TOWN OF UNDERHILL

Development Review Board

KEITH & TARA CARTER
SKETCH PLAN REVIEW
Docket #: DRB-19-09

Project Proposal:	Sketch Plan Review of Keith & Tara Cater for a proposed 2-Lot Subdivision of property located at the aforementioned address. The applicants have requested that the lot remaining as vacant lands be considered a “wood lot” in order to forgo a more in-depth review process.
--------------------------	--

SECTION 3.18 – STEEP SLOPES

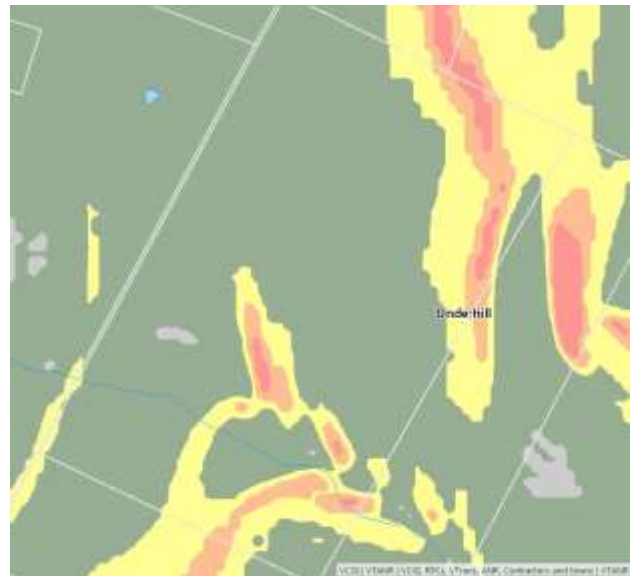
- Areas of steep slopes (15-25%) are present on the existing lot (see directly to the right).
 - The existing house appears to be in an area of Steep Slopes (15-25%).
- While the second, vacant lot will remain as a “wood lot,” thereby deferring development at this time, there are areas on that lot that are outside of these steep slopes and very steep slopes, allowing for future development.
